Property Alliance Group / Starwood Capital Group Renaissance Site

Residential Building Section 73 Application (141175/JO/2024)

Issue No. 03 23.10.25

5.2 Level 03
S73 Proposal

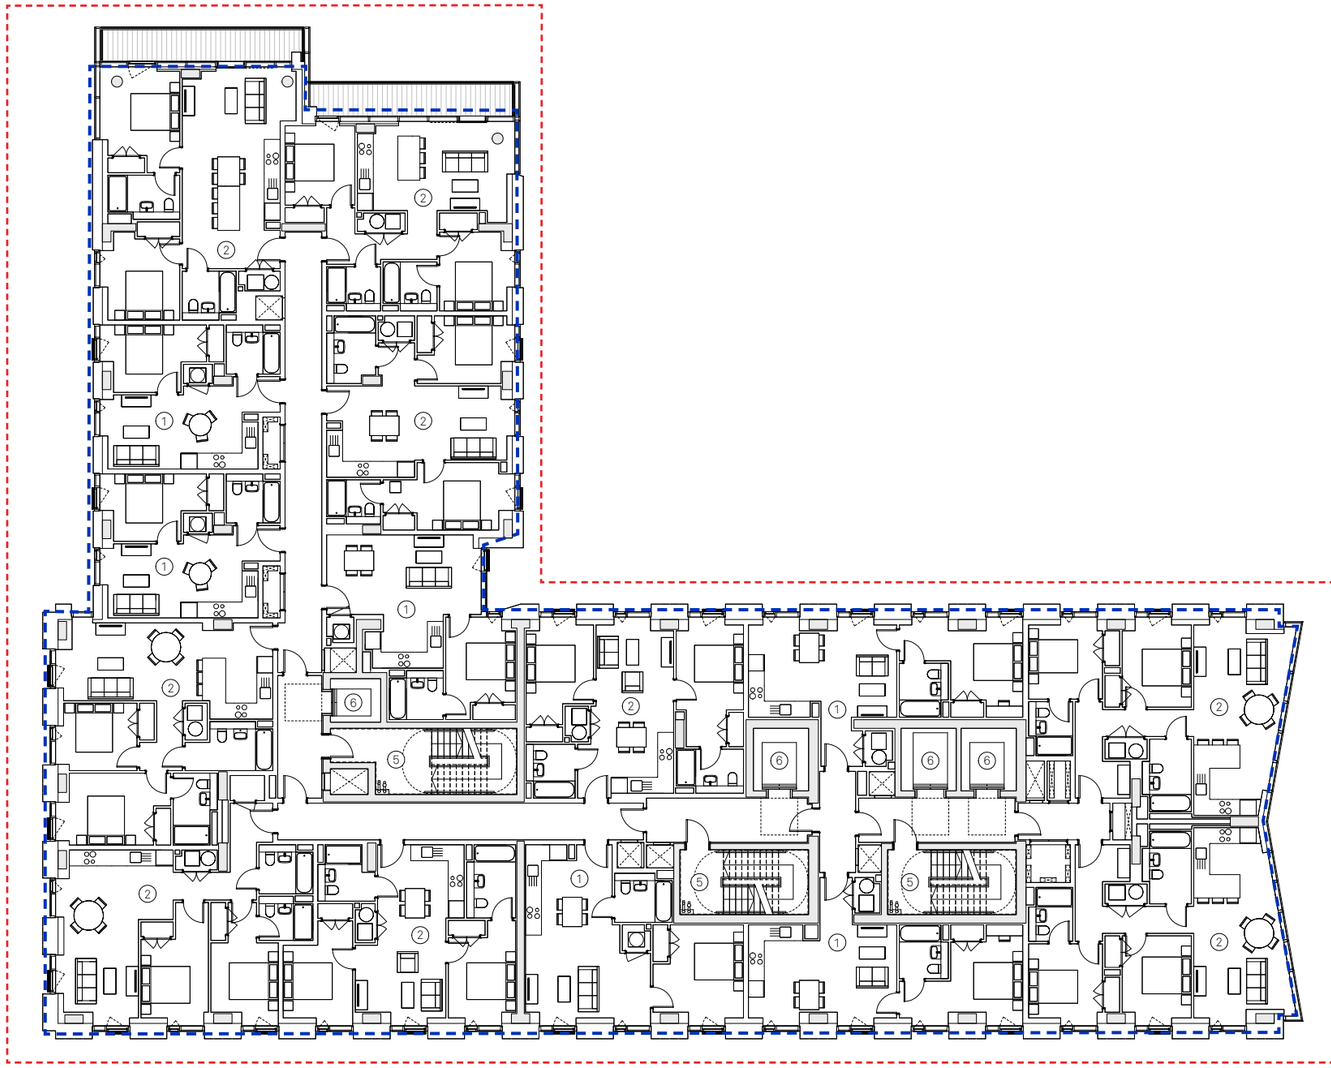
Sept 2024 Amendments:
(141175/JO/2024)
- Fire-fighting lobby added to all floors with an +1 additional stair and evacuation lift plus associated fire fighting lobbies.

5.2 Level 04
S73 Proposal

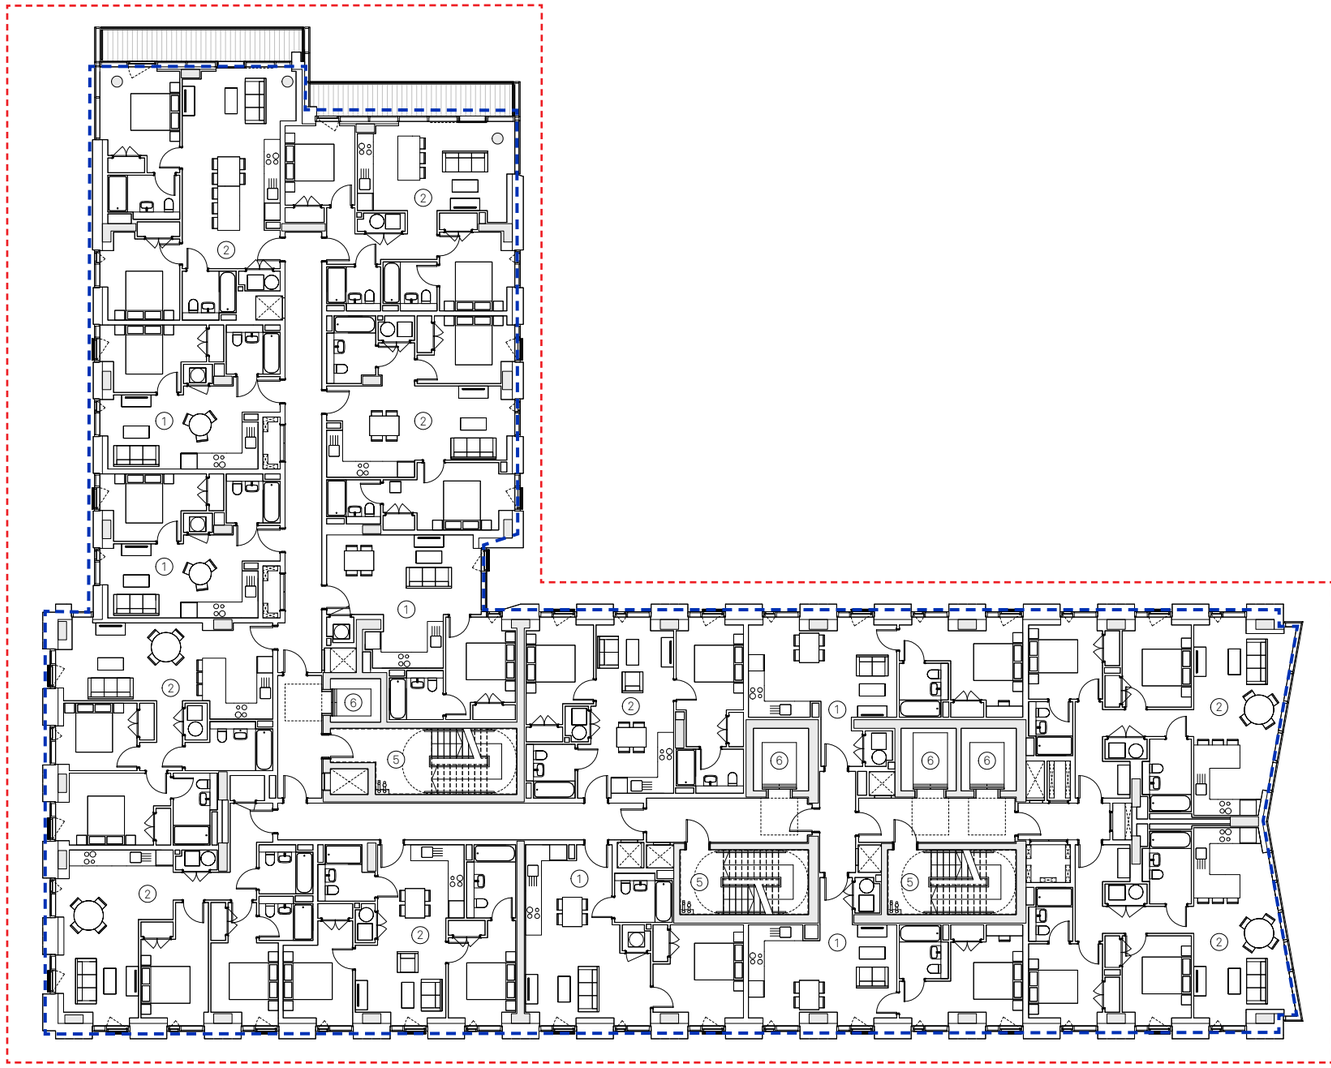
Sept 2024 Amendments:
(141175/JO/2024)
- Fire-fighting lobby added to all floors with an +1 additional stair and evacuation lift plus associated fire fighting lobbies.

5.2 Level 09
S73 Proposal

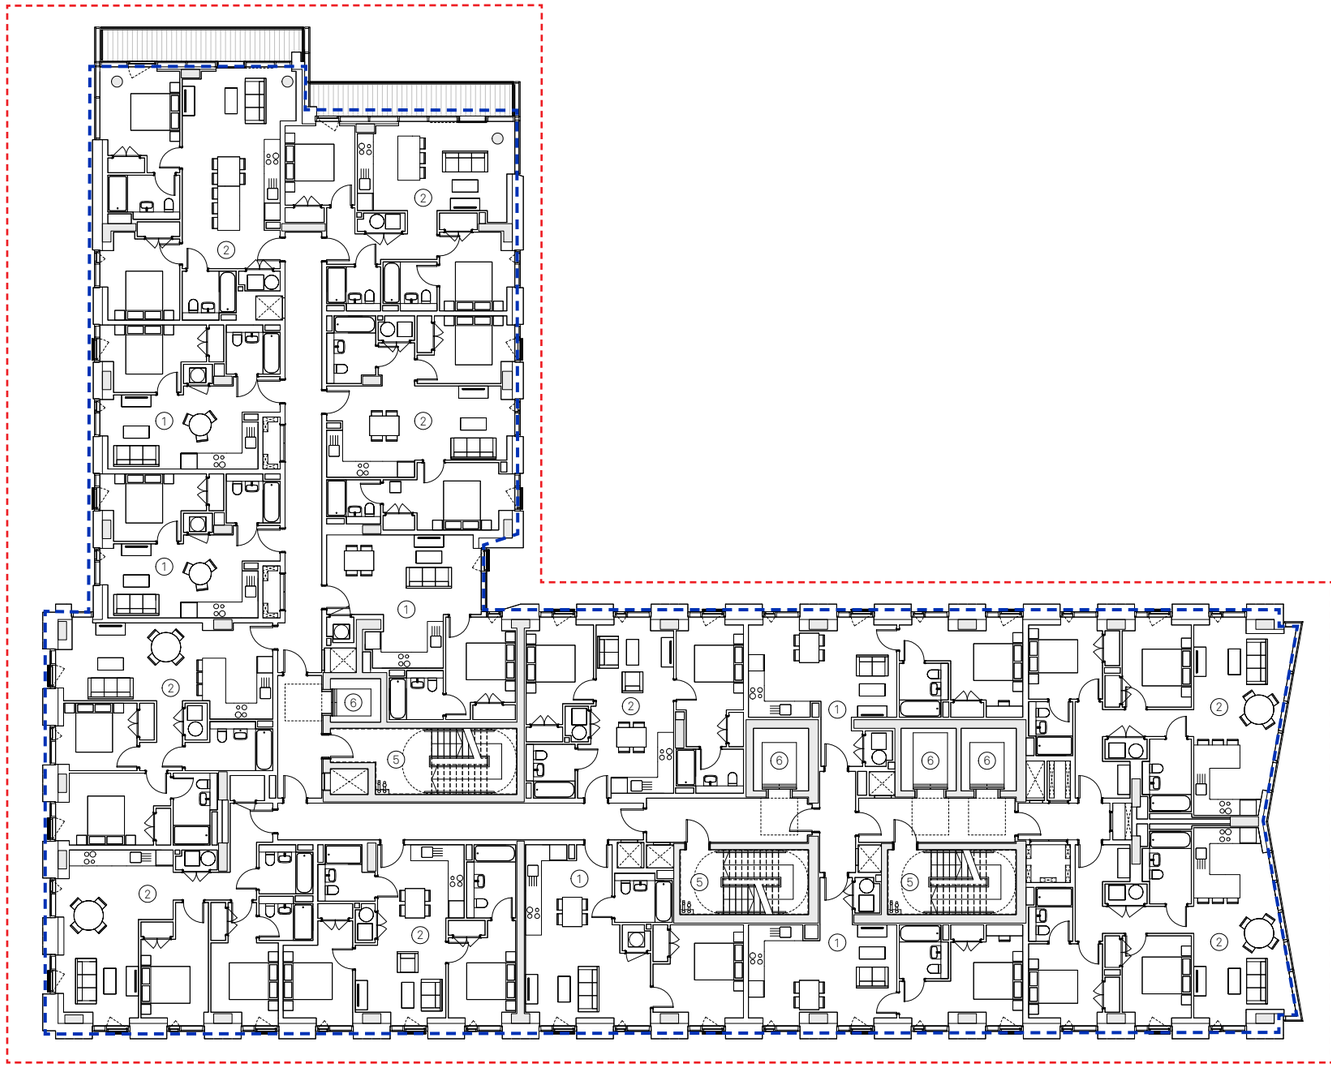
Sept 2024 Amendments:
(141175/JO/2024)
- Fire-fighting lobby added to all floors with an +1 additional stair and evacuation lift plus associated fire fighting lobbies.

5.2 Level 14
S73 Proposal

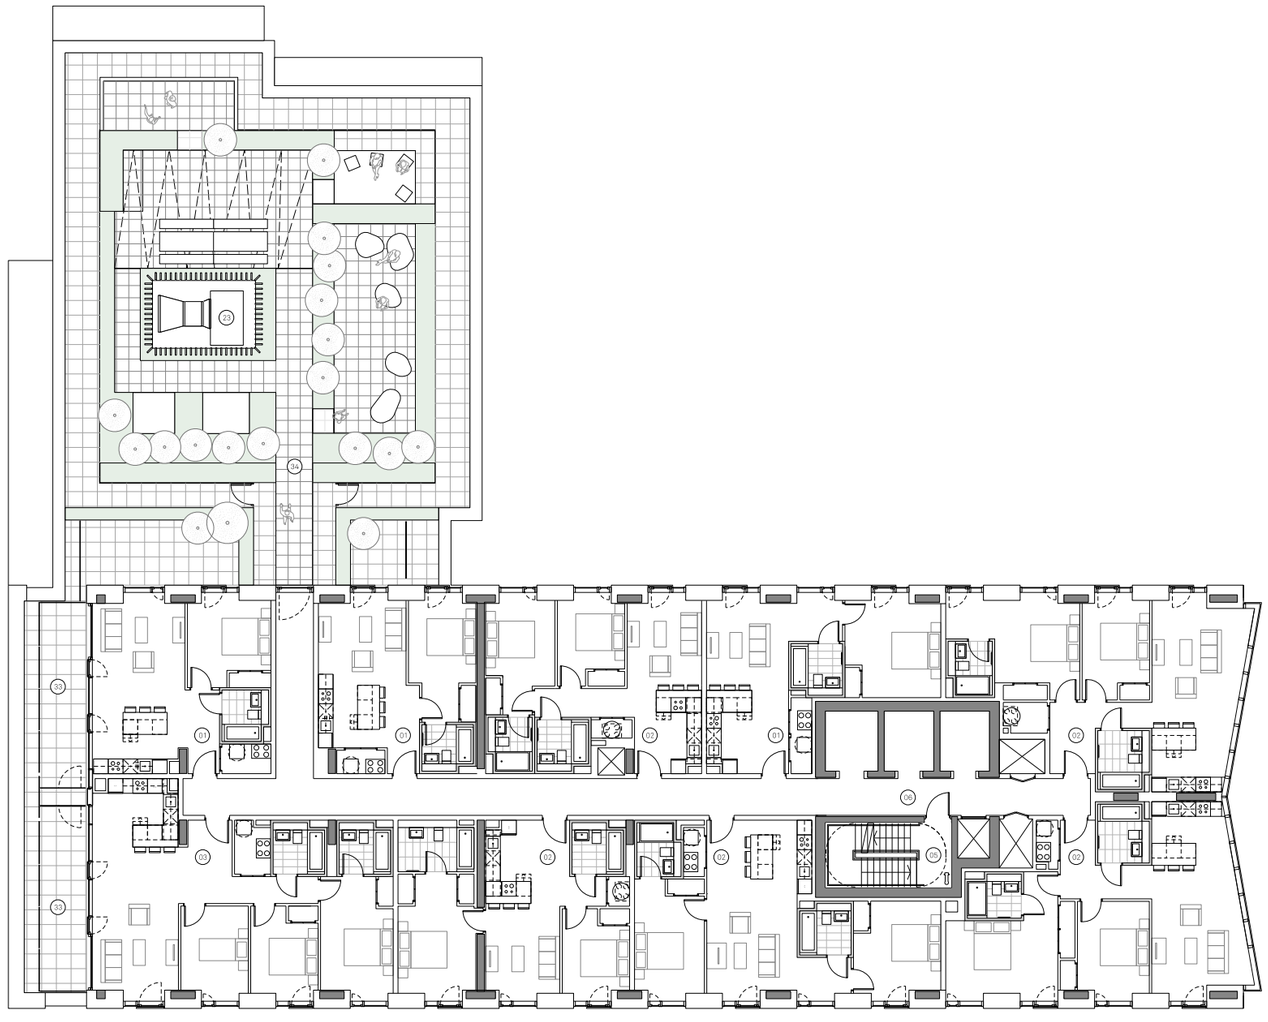
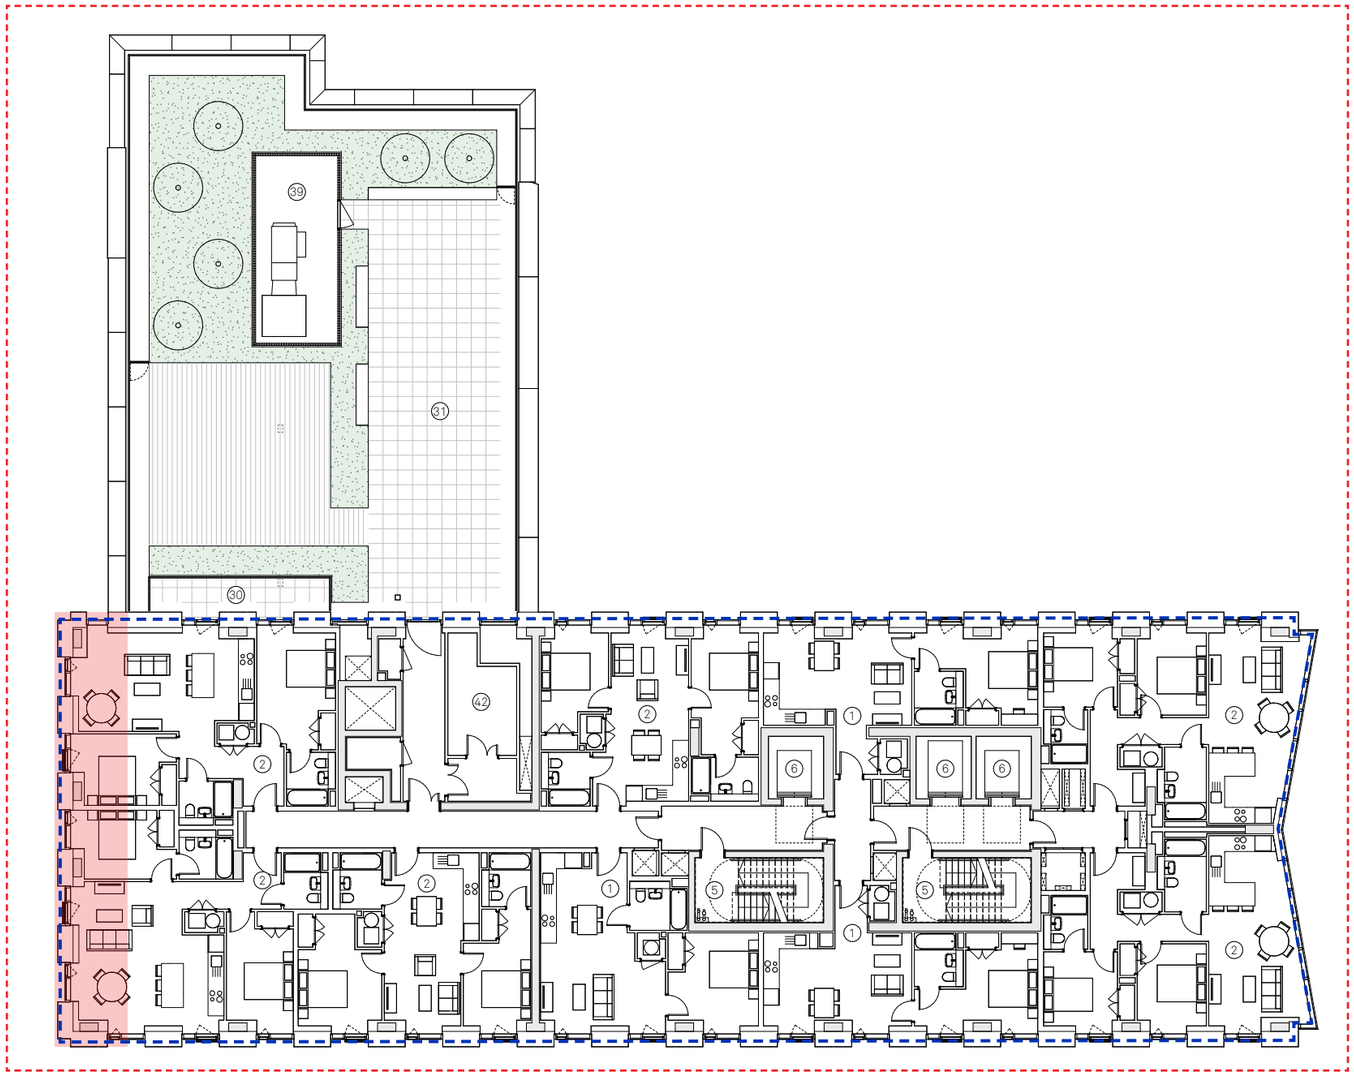
Sept 2024 Amendments:
(141175/JO/2024)

- Fire-fighting lobby added to all floors with an +1 additional stair and evacuation lift plus associated fire fighting lobbies.
- Internal floor plate extended into previous / consented external terrace area. Therefore 14th floor massing increased where identified.
- Scale, massing and elevation amendments proposed where the floorplate is extended.

5.2 Level 15
S73 Proposal

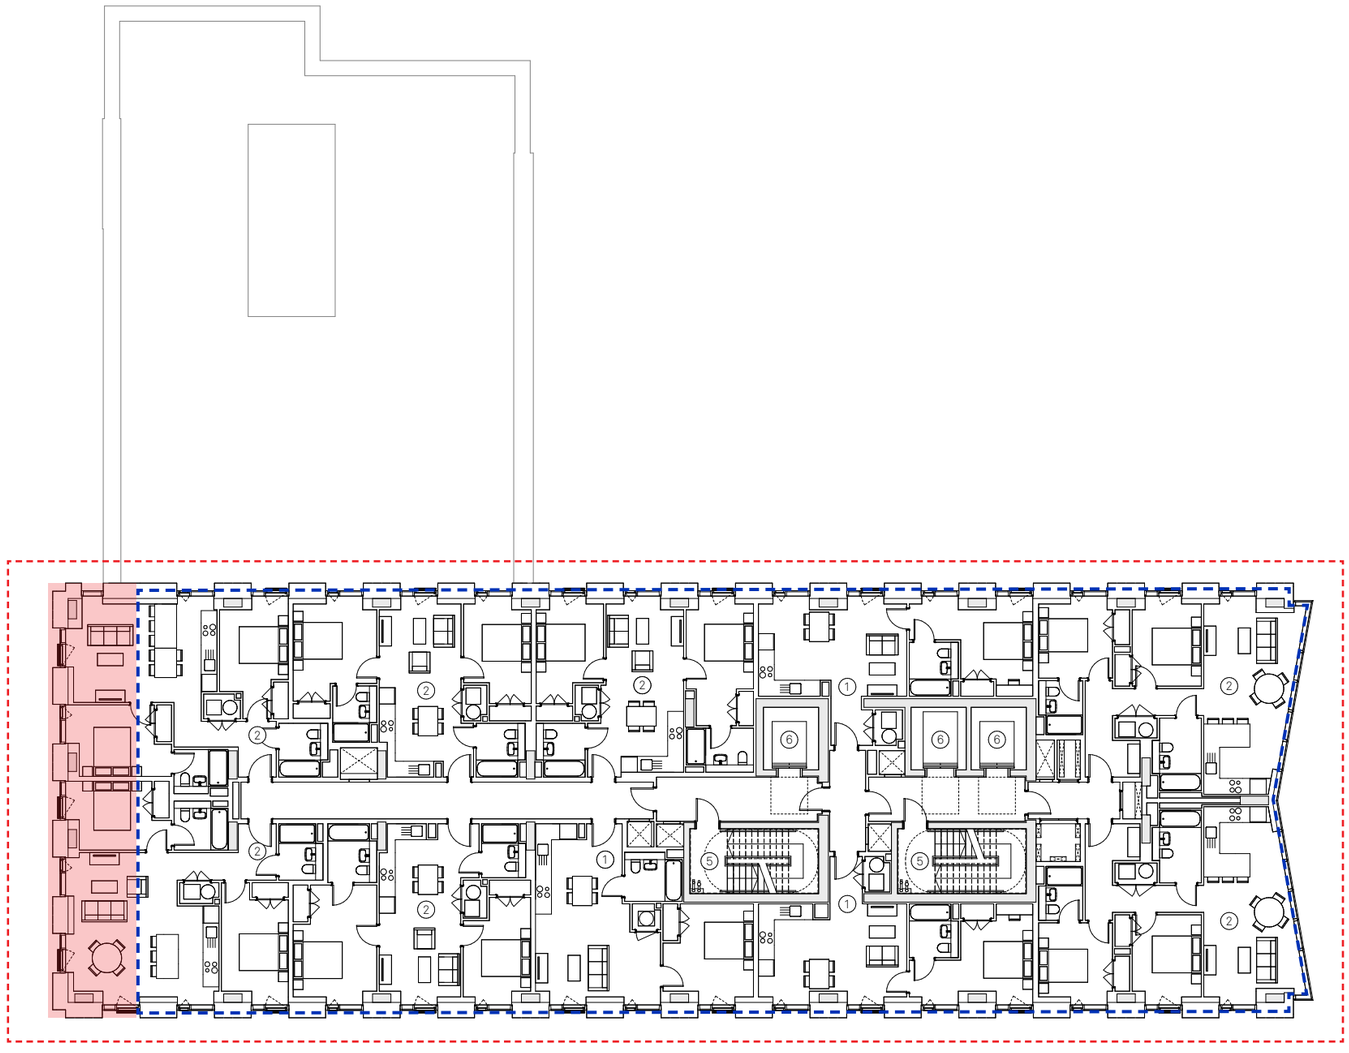
Sept 2024 Amendments:
(141175/JO/2024)
- Fire-fighting lobby added to all floors with an +1 additional stair and associated fire fighting lobbies.
- Internal floor plate extended into previous / consented external terrace area. Therefore 15th floor massing increased where identified.
- Scale, massing and elevation amendments proposed where the floorplate is extended.

5.2 Level 18-19
S73 Proposal

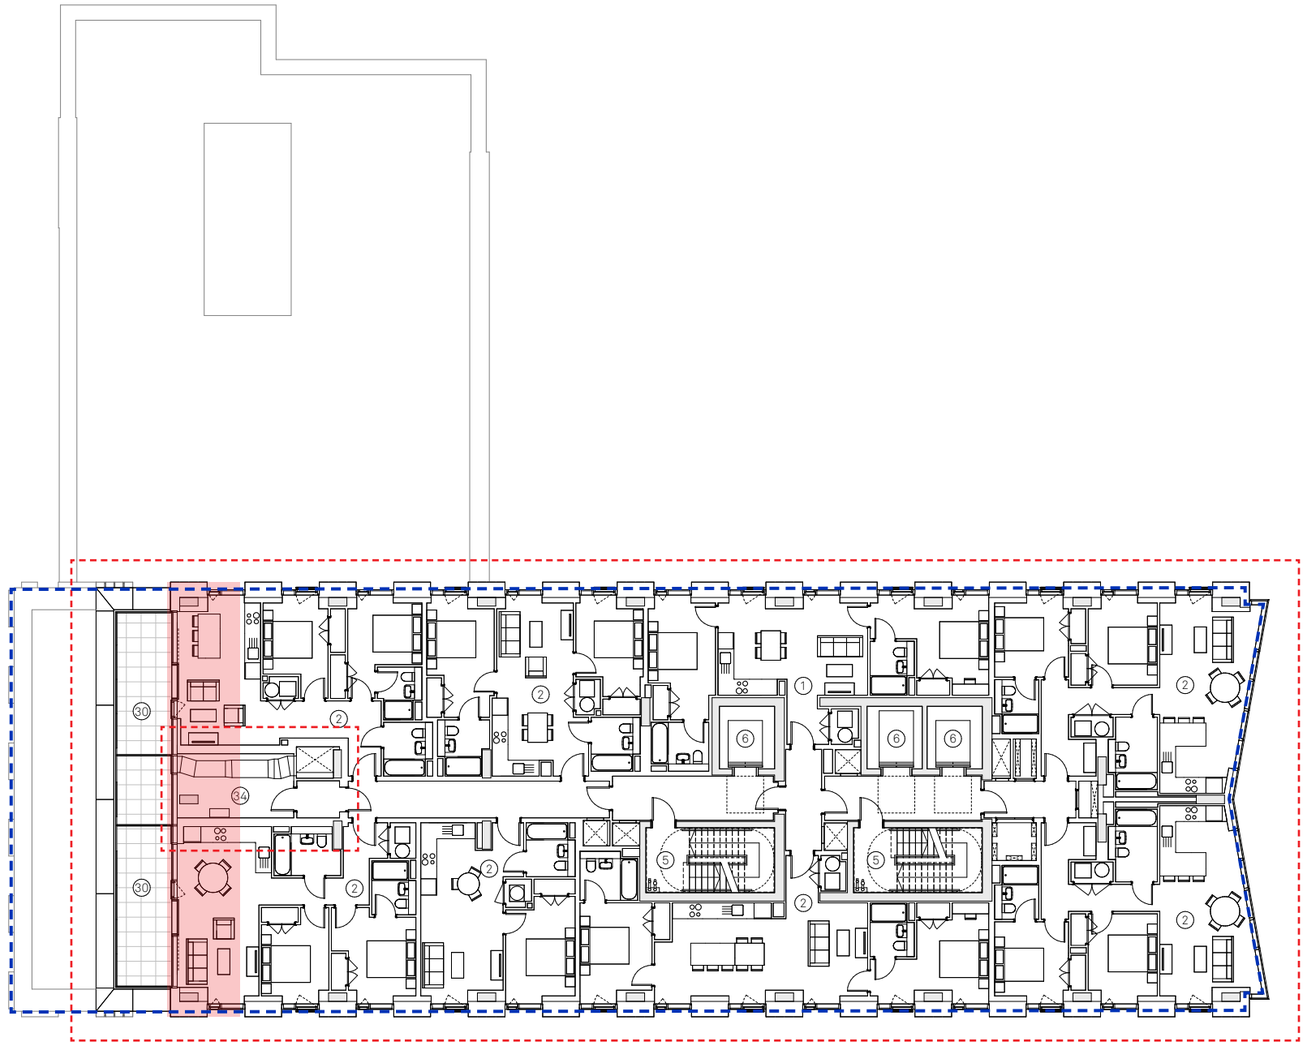
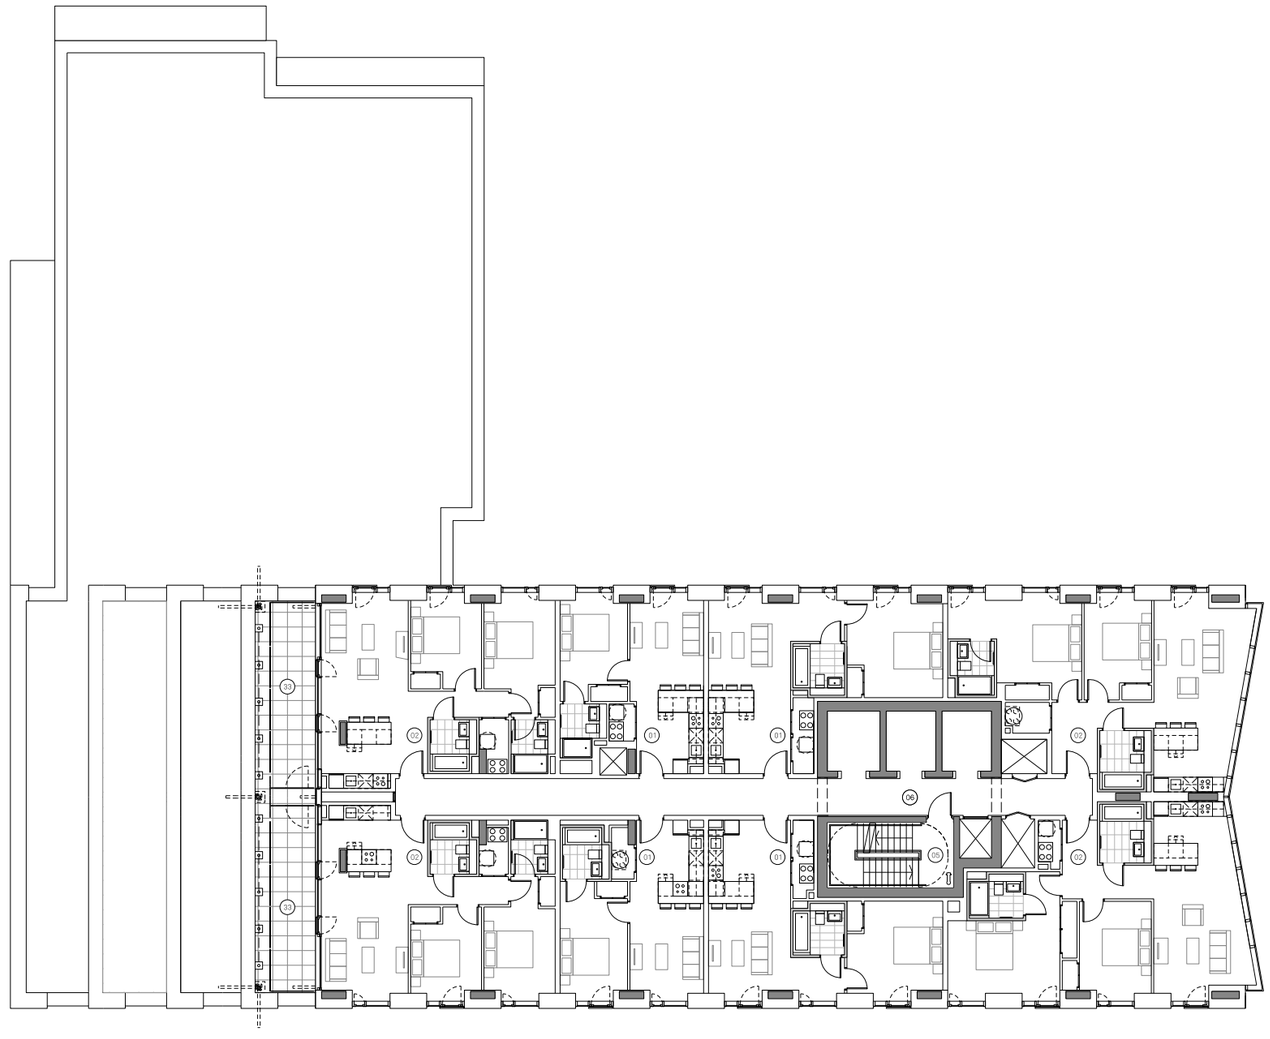
Sept 2024 Amendments:
(141175/JO/2024)
- Fire-fighting lobby added to all floors with an +1 additional stair and associated fire fighting lobbies.
- Internal floor plate extended into previous / consented external terrace area. Therefore the 18th & 19th floor massing increased where identified.
- Scale, massing and elevation amendments proposed where the floorplate is extended.
